**RE: Multi-Specialty Clinic
Grading and Drainage Plan
Engineer's Stamp Date 11-20-2015 (File: M15D026B)**

RE: Multi-Specialty Clinic Grading & Drainage (File M15-D026B)

Please find the following responses addressing staff comments from correspondence dated July 18, 2015 listed below:

ENGINEER'S SEAL	MULTI-SPECIALTY CLINIC 2901 TRANSPORT ST, S.E. STORM DRAIN DETAILS	DRAWN BY DY
		DATE 11/06/15
		2015044-SD DETAILS
		SHEET # SD-2
		 TIERRA WEST, LLC 5571 MIDWAY PARK PLACE NE ALBUQUERQUE, NM 87109 (505) 858-3100 www.tierrawestllc.com
JOEL D. HERNANDEZ P.E. #17893	JOB # 2015044

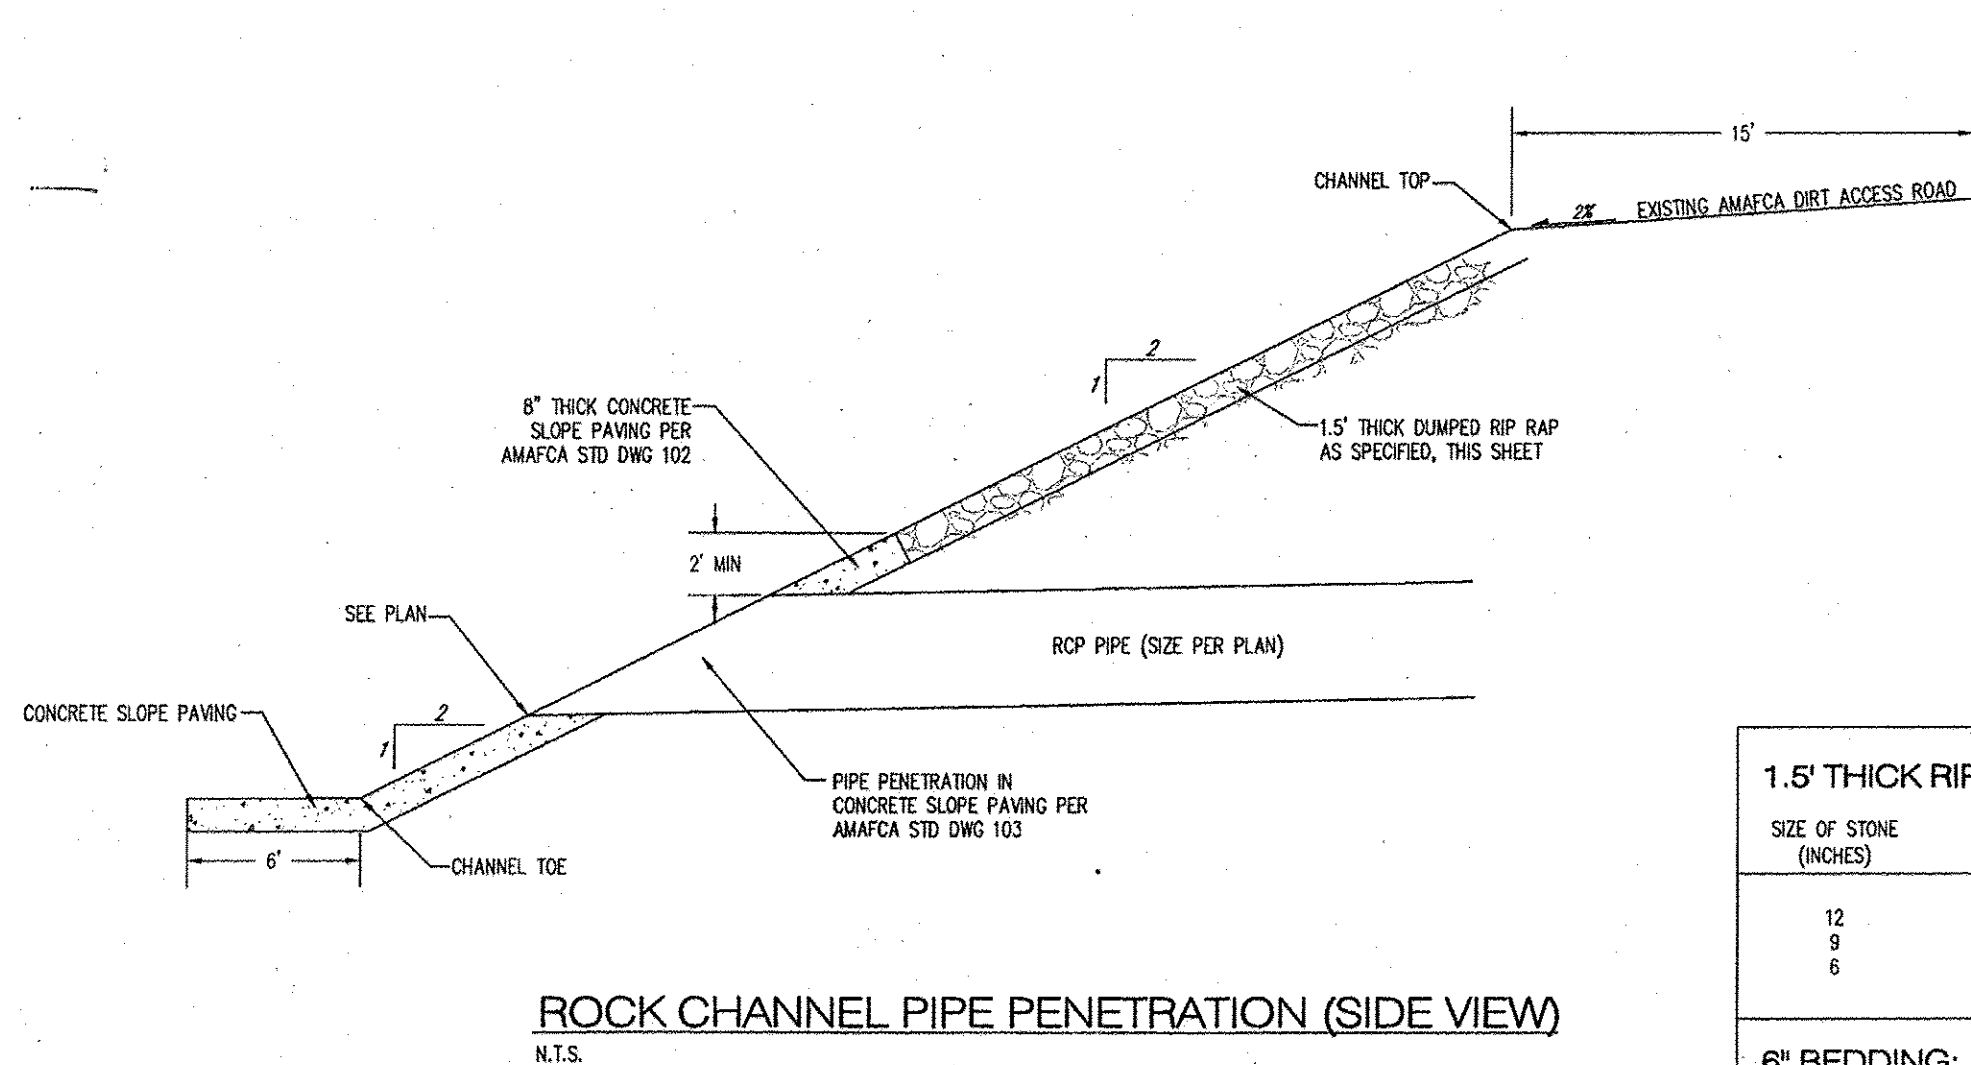
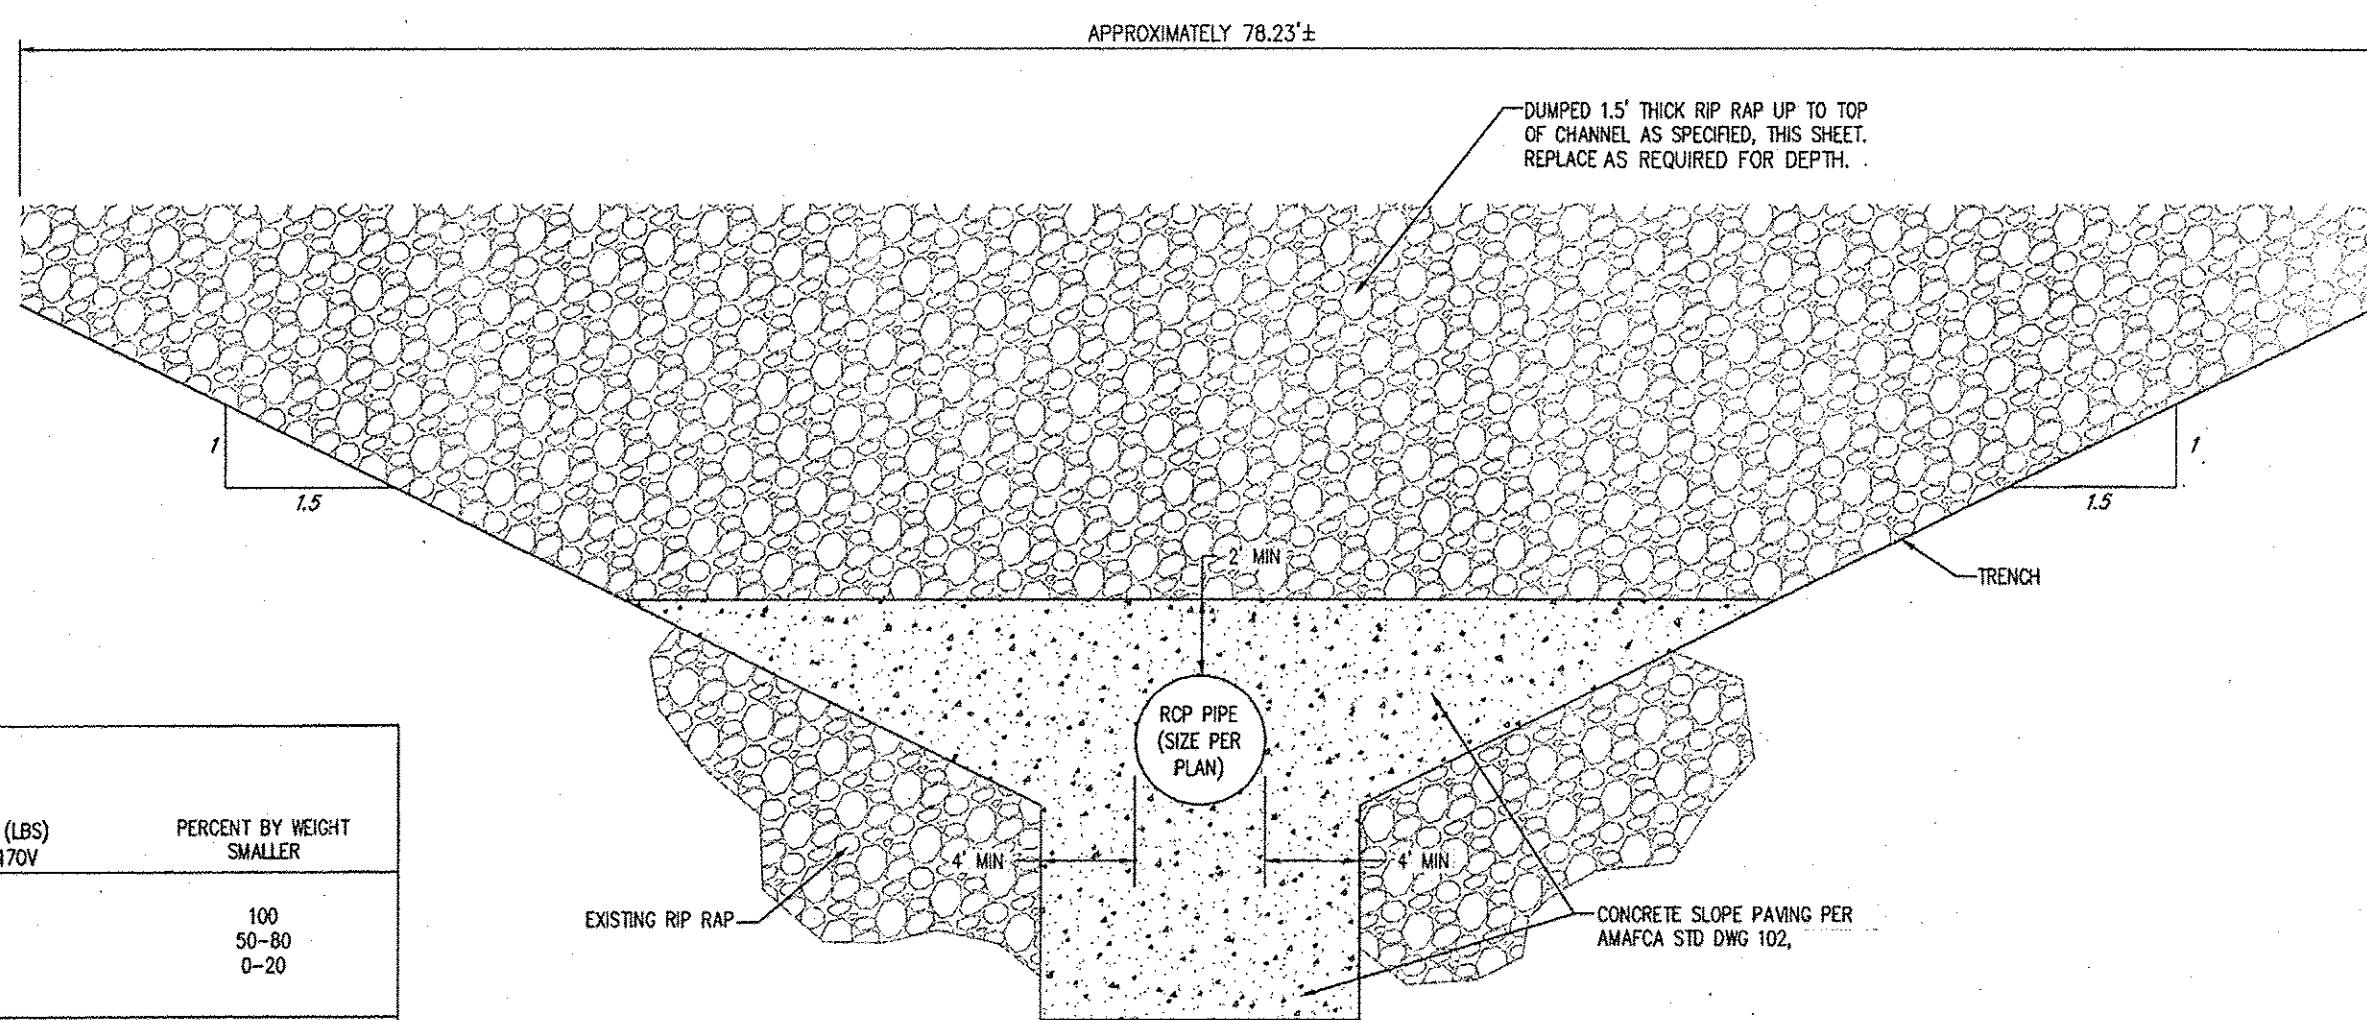
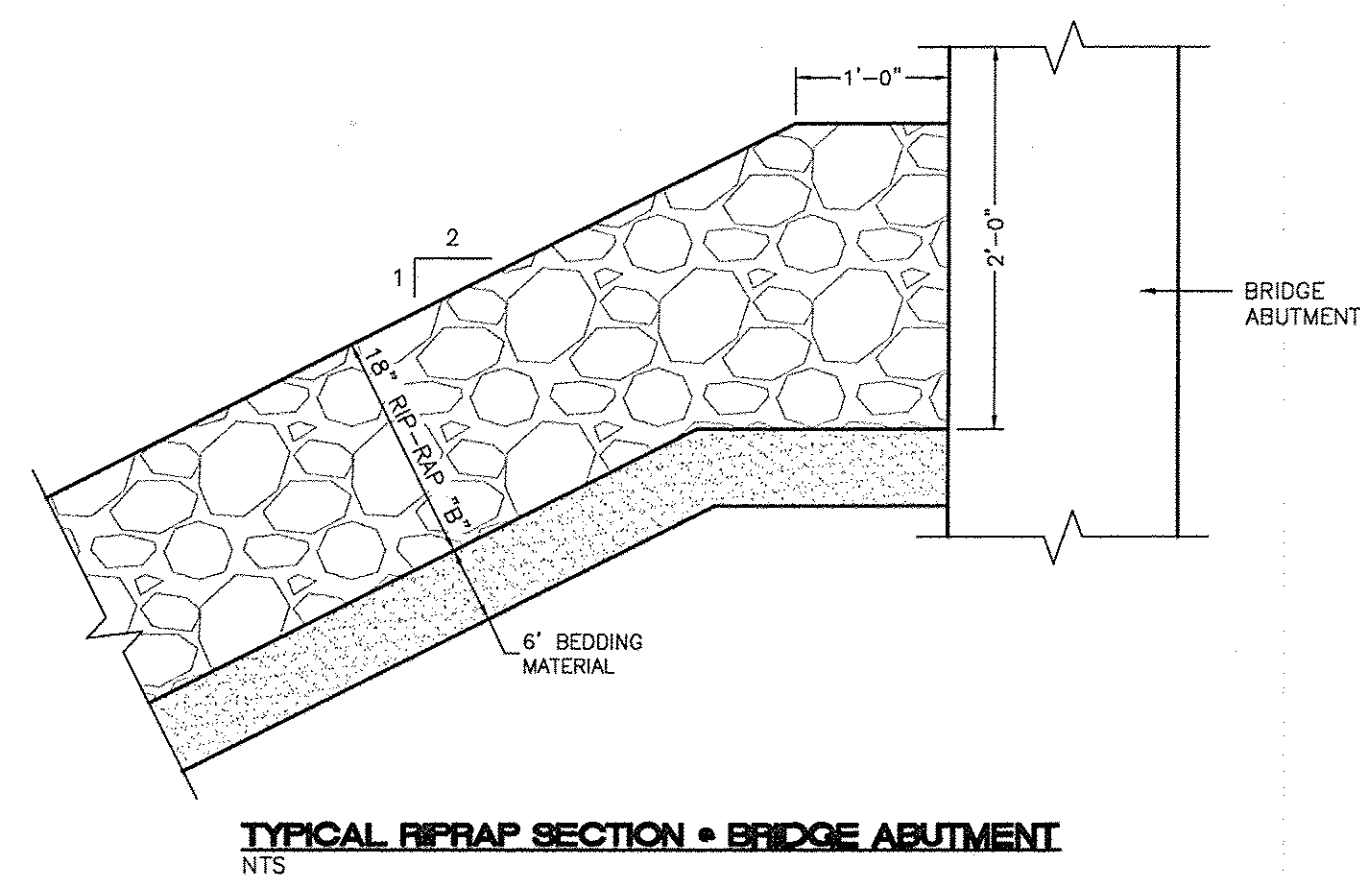
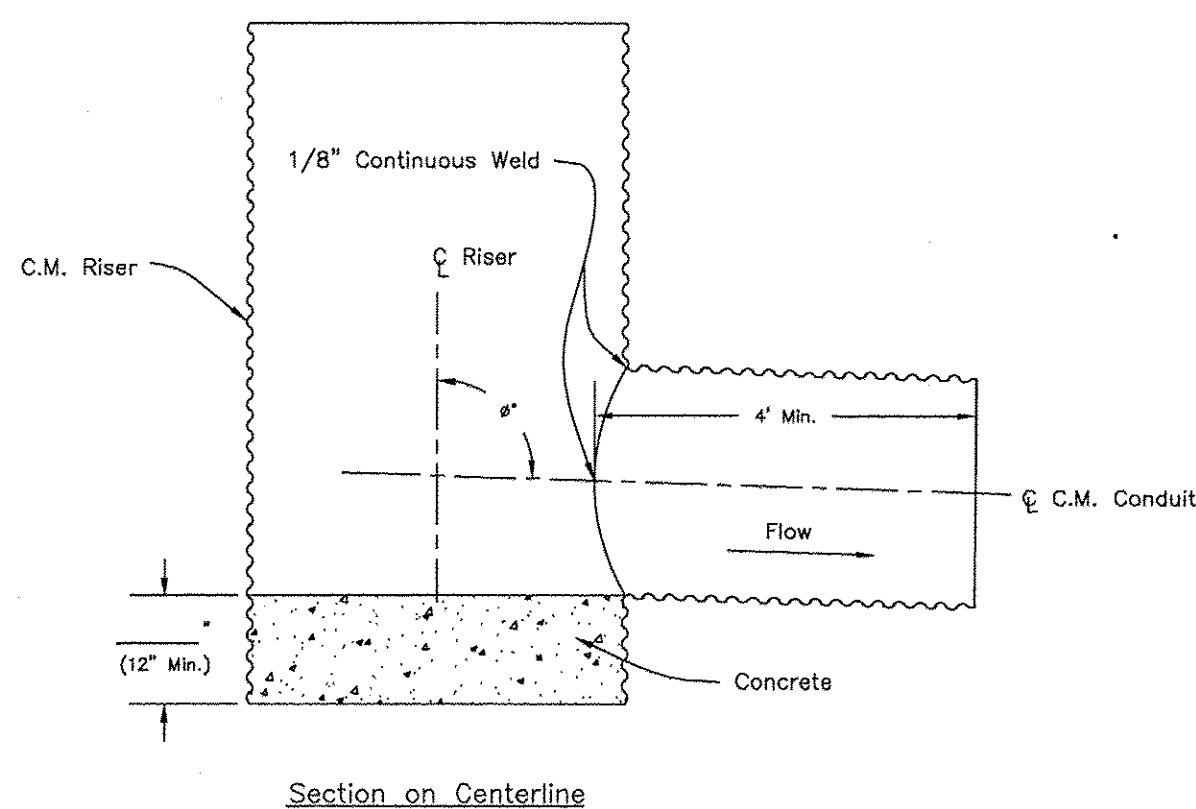
10. Sheet GR-2 references the concrete flume detail on SD-2, but it is not shown. Also, adjust the capacity worksheet to match the dimension (4' bottom width) shown on the plans.

Response: We have added the concrete flume detail to sheet SD-2 and included a revised capacity worksheet to match the 4-foot bottom width dimension as shown on the plans.

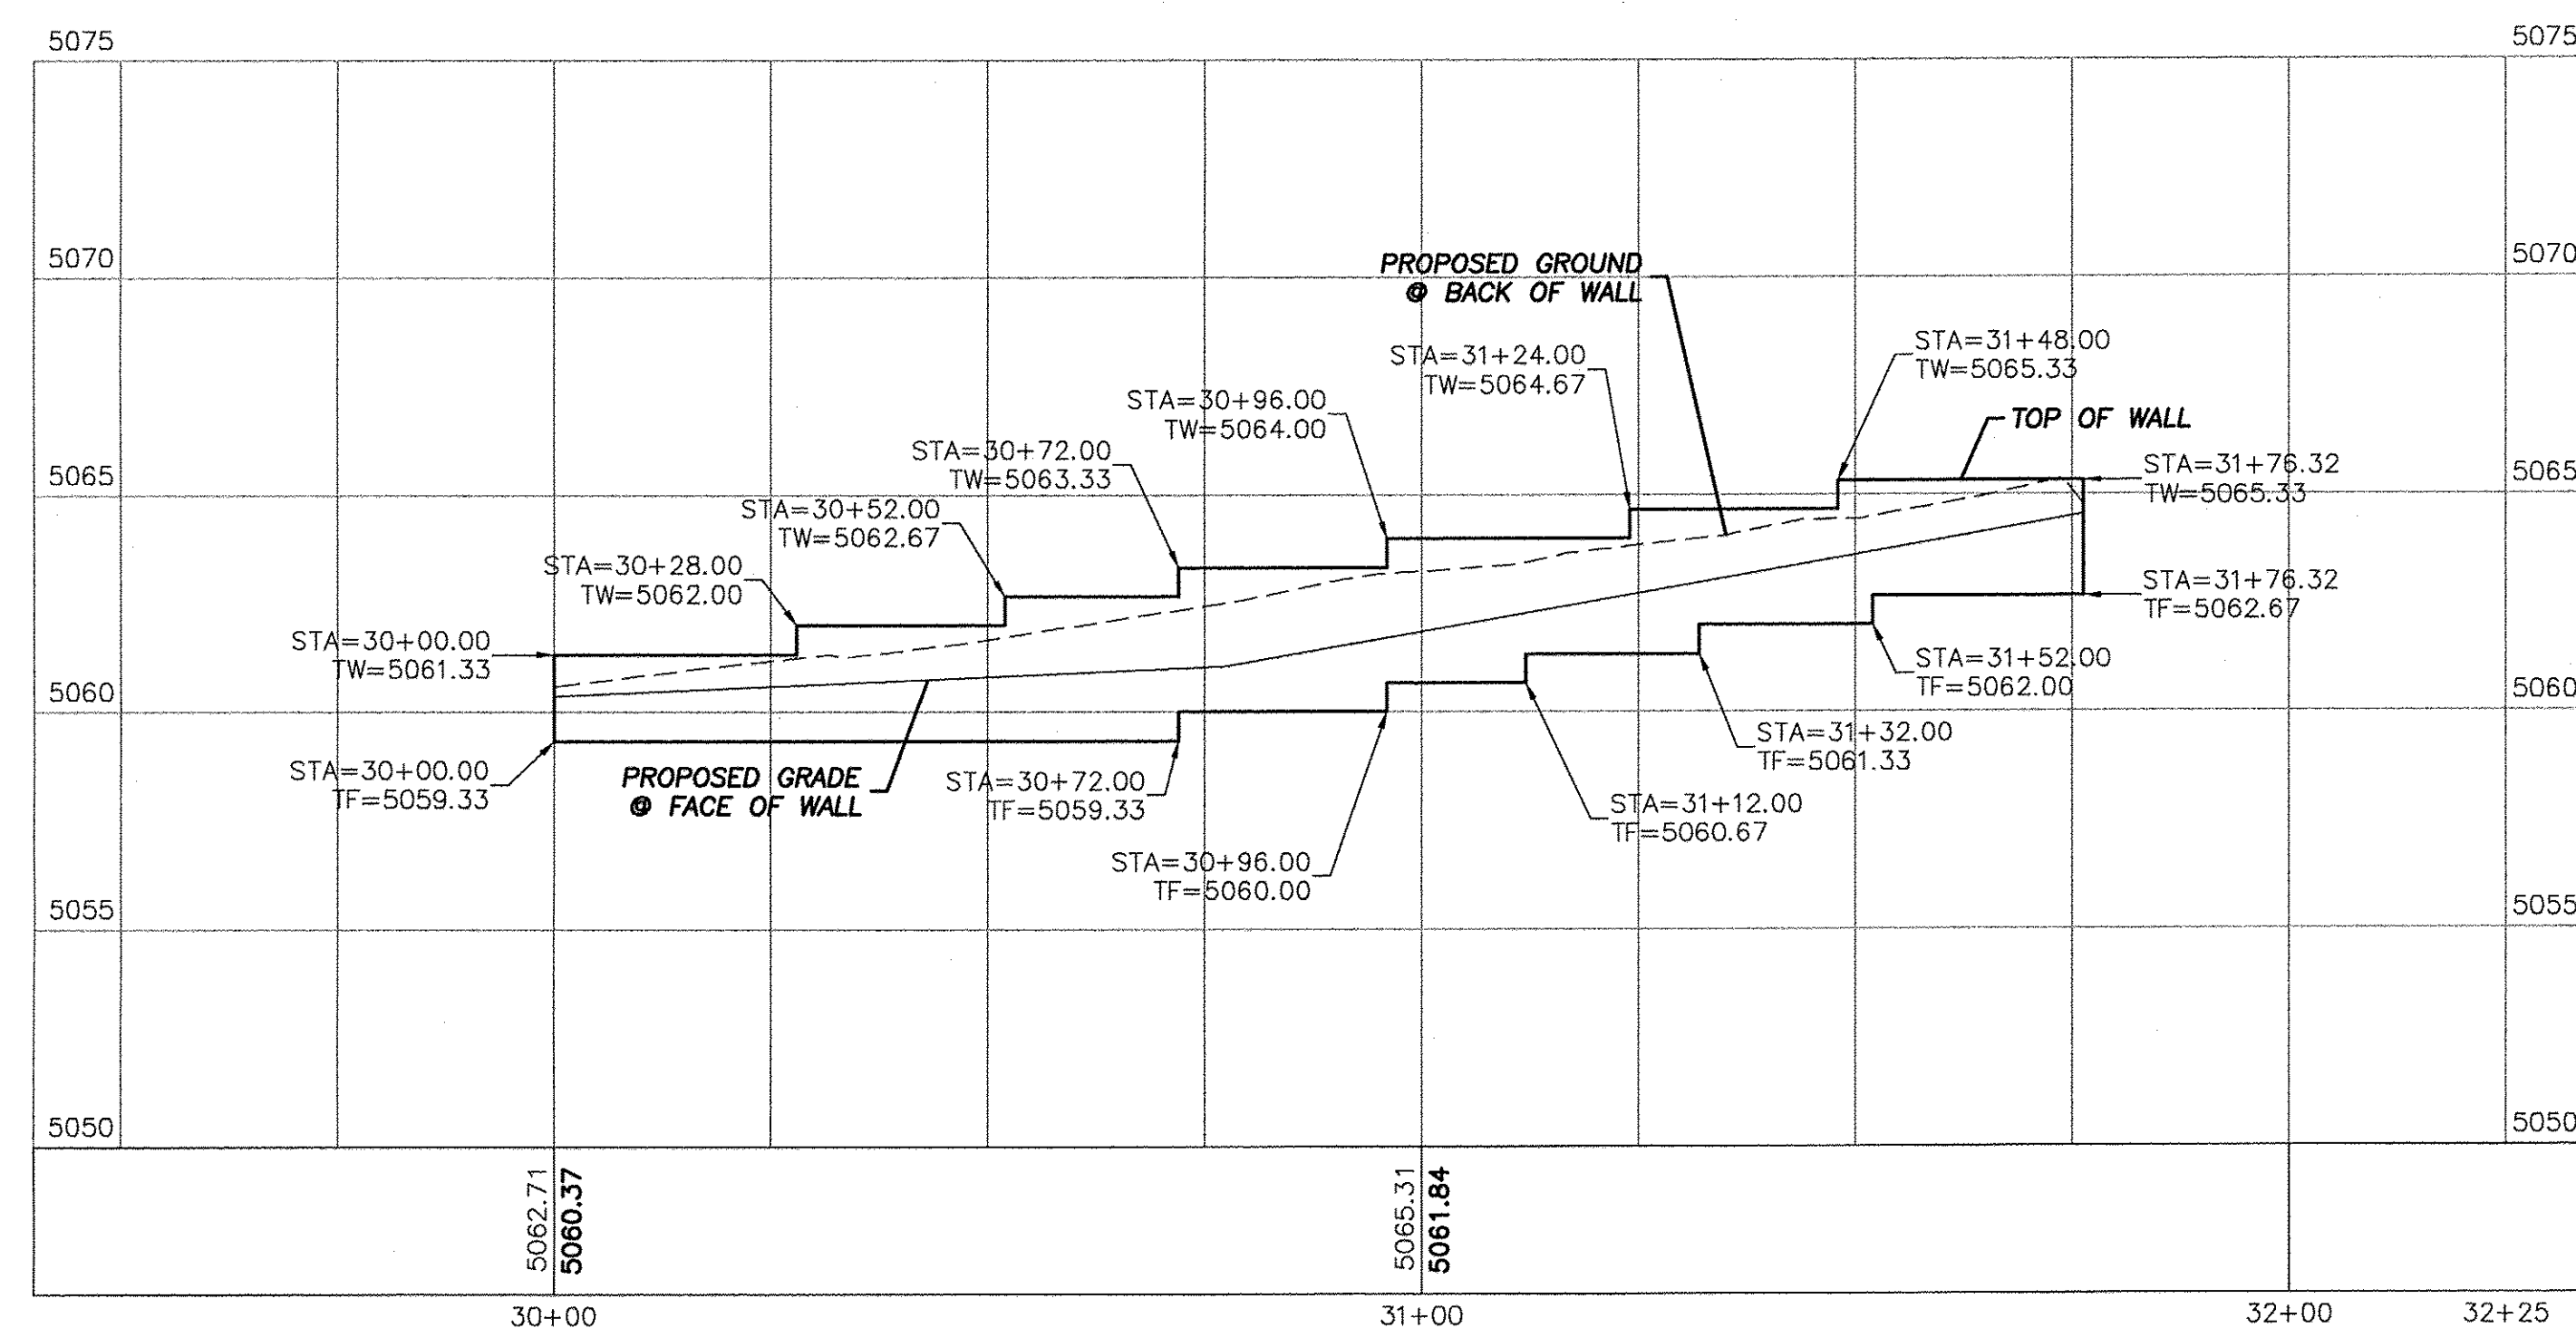
2. Sheet RW-1 shows a back of wall profile that has a 2-foot drop, which implies that, the trail profile would have the drop as well.

Response: We have revised the location of the bike trail to be within the trail right of way and adjusted the retaining wall location such that the trail elevation is unaffected by the retaining profile. Please see the typical section added to Sheet GR-2 which depicts the relationship between the wall and trail.
